Reinforcement detail  
(2 holes version)

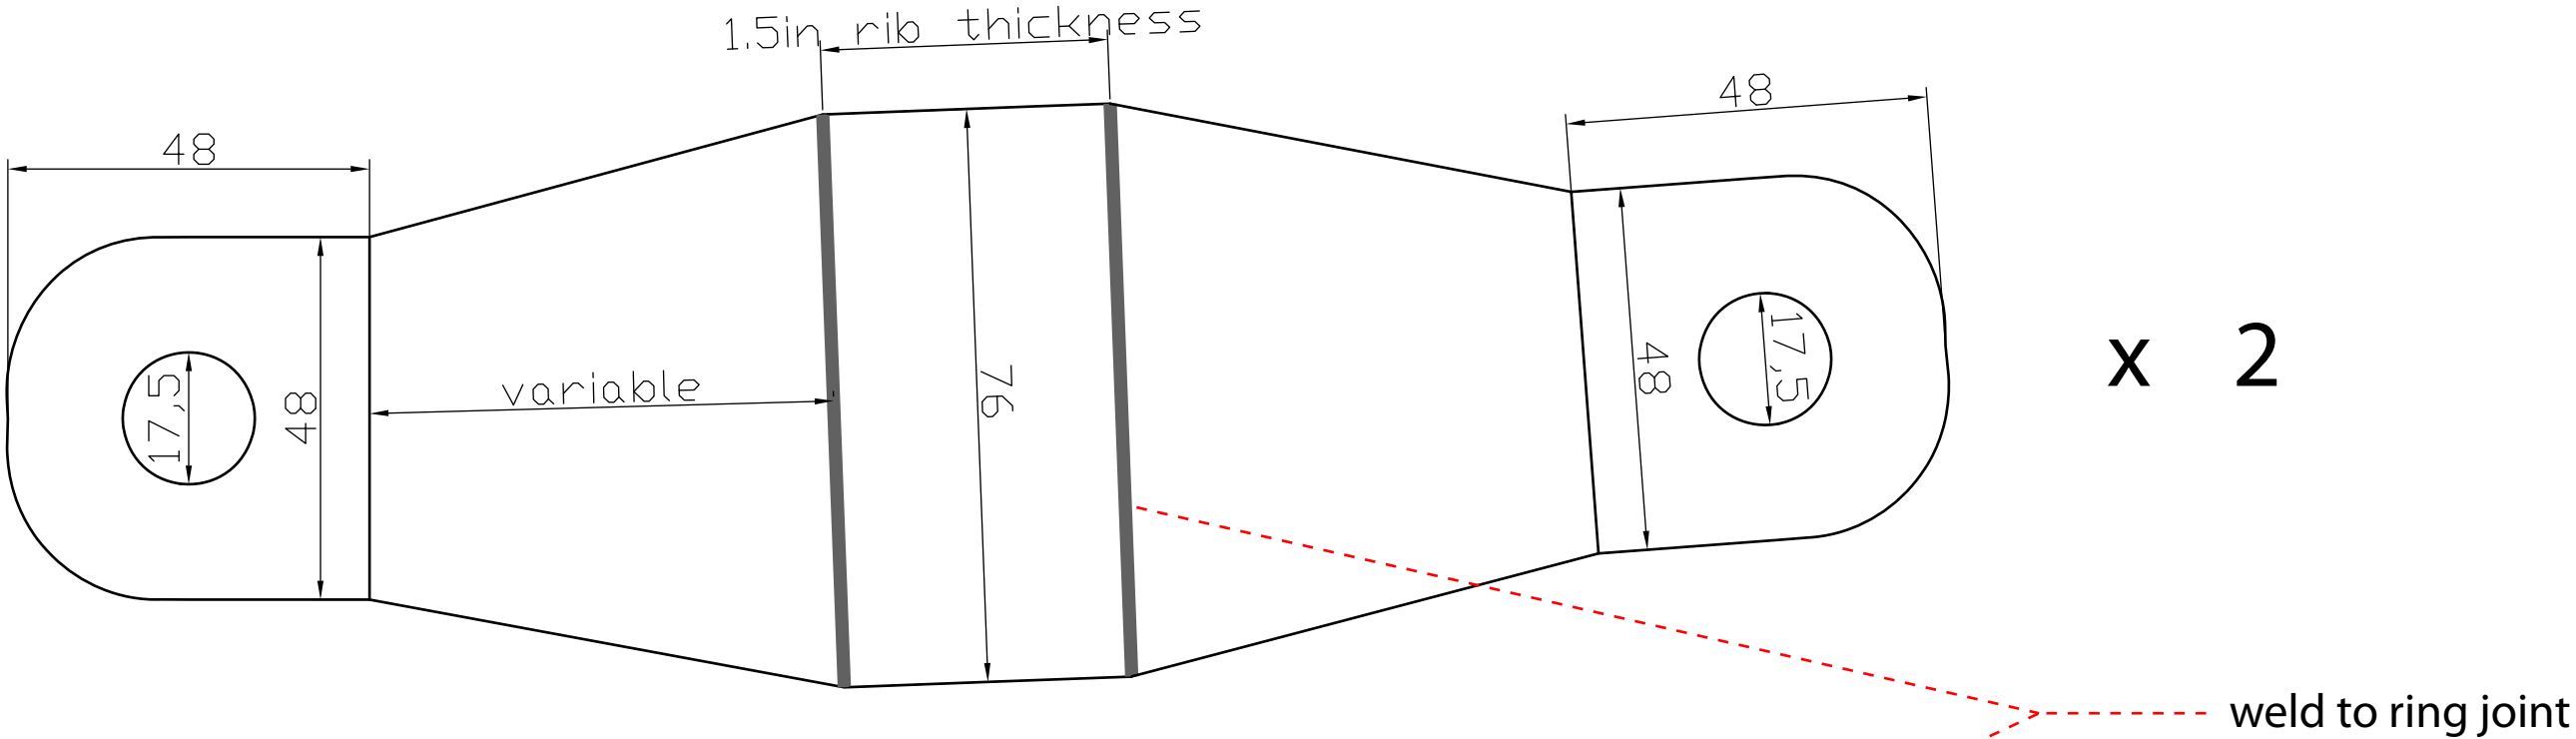
Reinforcement detail  
(3 holes version)  
could be the same size as the 2 holes version  
since it does not rely on the ring joint anymore
